Reference: NHTSA Identification Number 06V-339

Safety Recall F42 Unused Wiring Connector

2001-2003 (DN) Dodge Durango

Figure 1

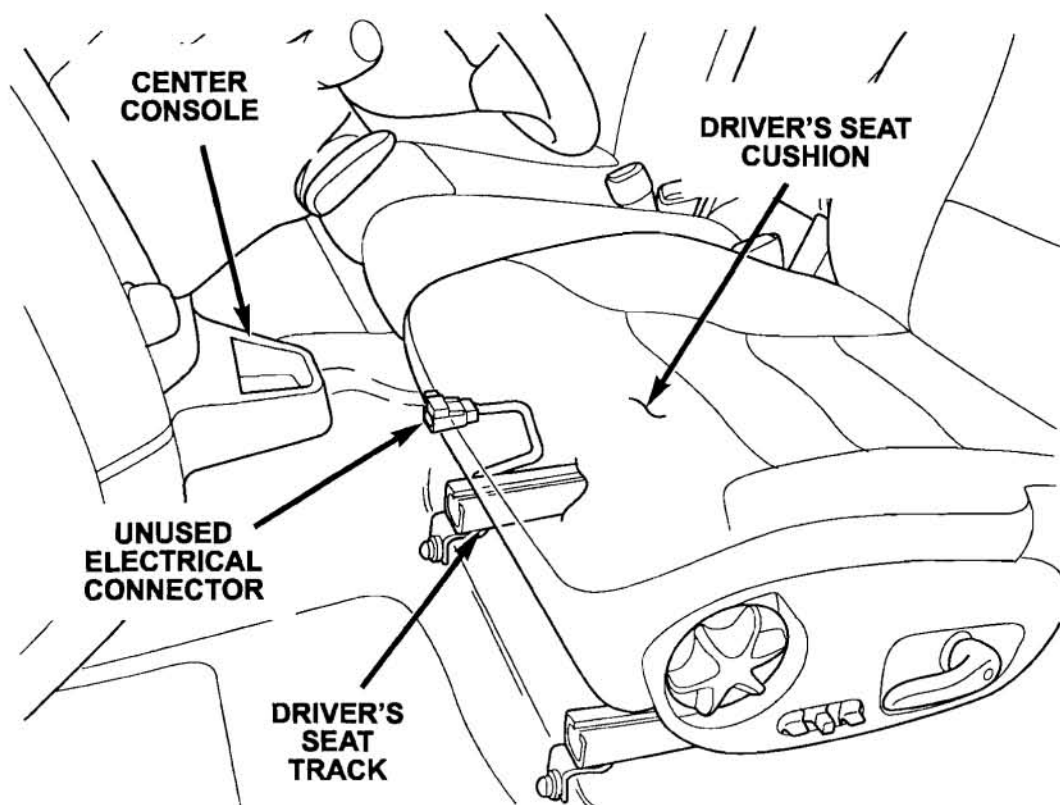
An unused wiring connector under the front seat on about 34,900 of the above vehicles may become contaminated with spilled fluid and/or debris. This may cause a short circuit, which can result in an interior fire.

1. Open the driver's door and move the driver's seat to the full rearward position.
2. Locate the unused electrical connector under the driver's seat near the transmission tunnel (Figure 1).

3. Slide the red locking tab towards the driver's side of the vehicle to release the primary lock on the connector.
4. Squeeze the tail end of the male connector to release the secondary connector lock and pull the connector apart.
5. Inspect the wiring harness side of the connector for corrosion and/or debris. If corrosion and/or debris is found, use Electrolyte Detection and Neutralizing Spray (P/N CBEJD201) to clean the corrosion and/or debris from the connector.

Figure 2

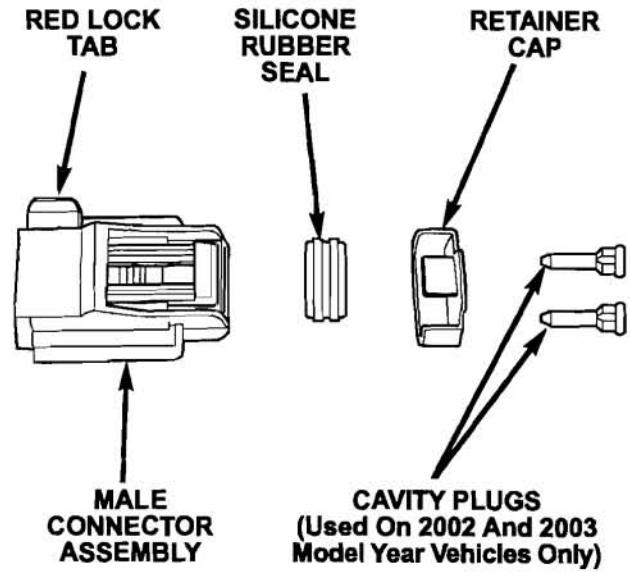
The unused connector under the front seat must be inspected for corrosion/debris and cleaned as necessary. In addition, a connector seal with a plastic retainer clip must be installed on the unused connector.

6. Install the connector end seal, retainer cap and cavity plugs into the empty male connector (removed in Step 4) as shown in Figure 2.

7. Install the male connector onto the unused wiring harness connector and engage the red lock tab by sliding the lock tab towards the passenger side of the vehicle (Figure 2).
